Office Action Summary	Application No.	Applicant(s)
	10/730,645	ADAMS ET AL
	Examiner	Art Unit
	Peter T. deVore	3751

DETAILED ACTION

FIG. 1

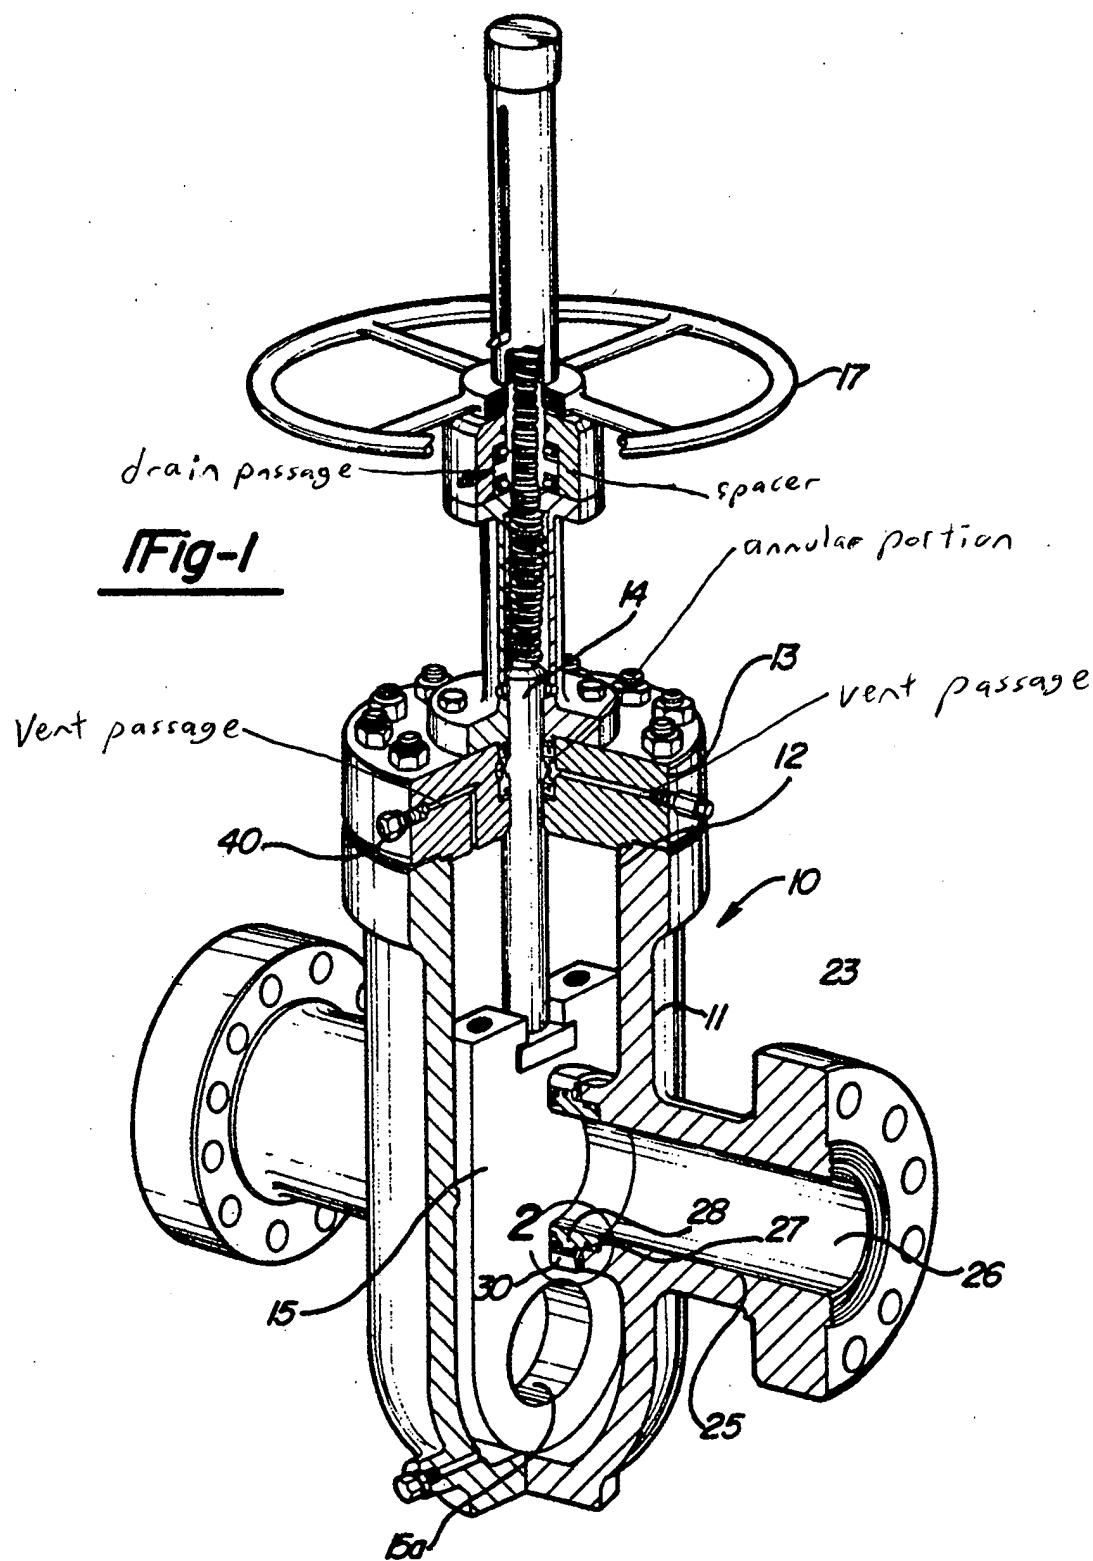
The Parks reference discloses a fluid control valve comprising a body 10, first and second fluid passages (the main inlet and outlet of the body, see Fig. 1), a movable member (stem 14 and valve element 15) within a bore (see Fig. 1), an actuator 17, and a plurality of vent passages, an annular portion, a spacer, and a drain passage (see attached annotated copy of Fig. 1).

Annotated Roberson Fig. 1

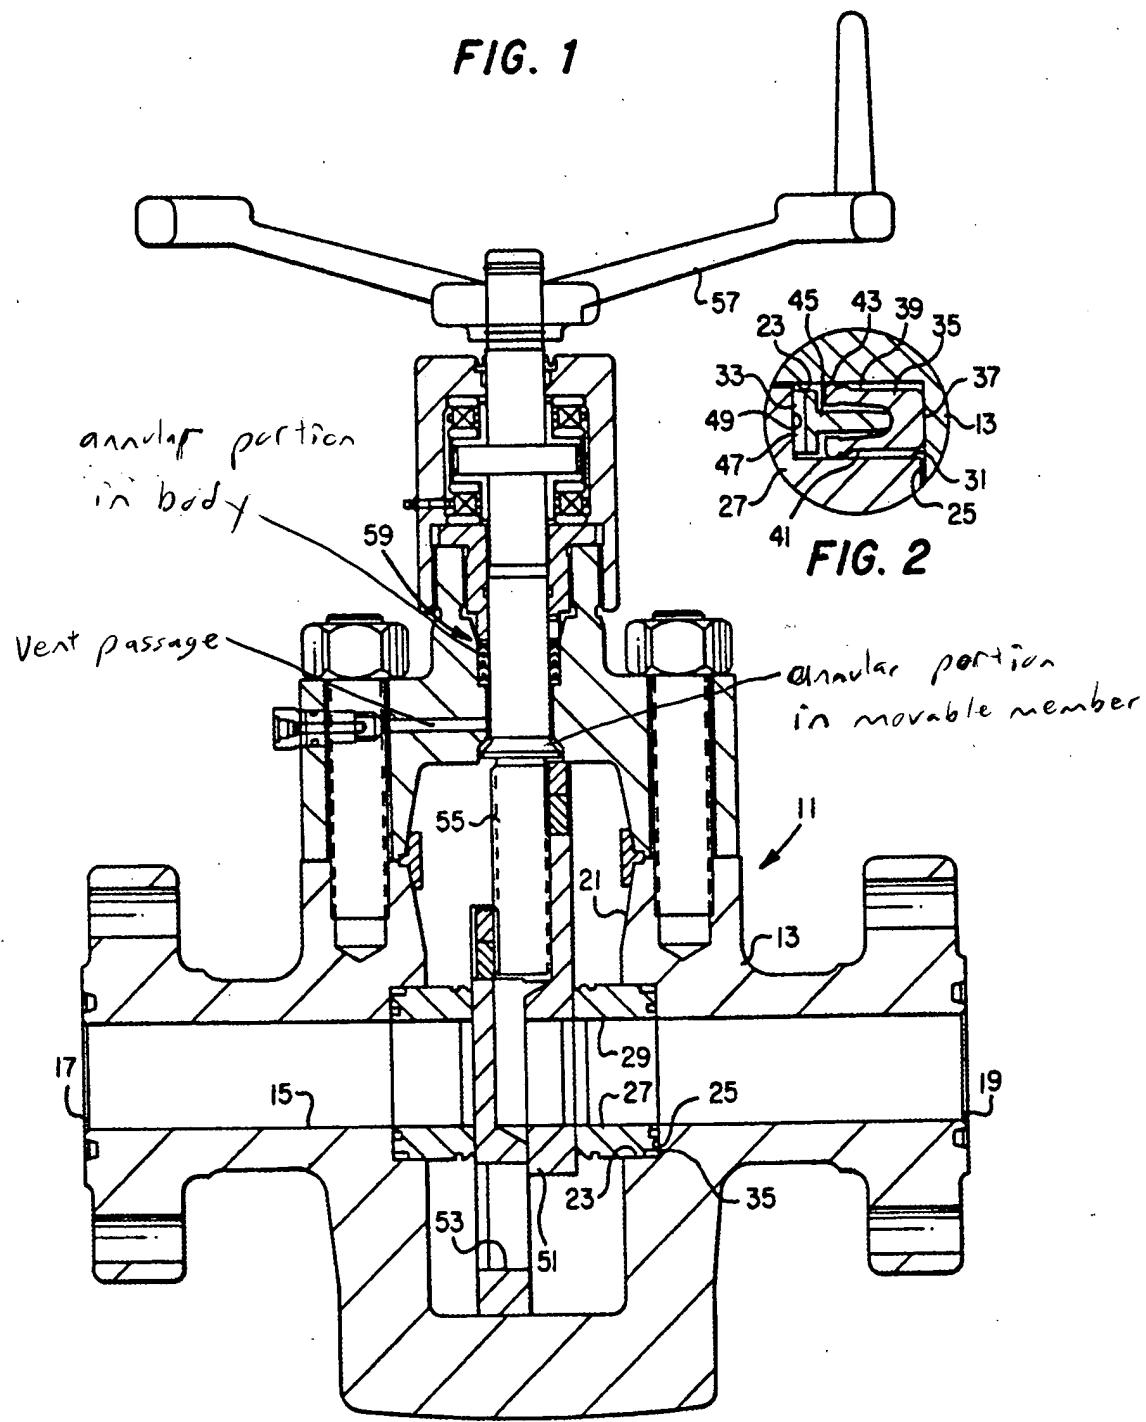
The Roberson reference discloses a fluid control valve comprising a body 11, first and second fluid passages 17 and 19, a movable member (stem 55 and valve element 51) within a bore (see Fig. 1), an actuator 57, and a vent passage and annular portions in the body and movable member (see attached annotated copy of Fig. 1).
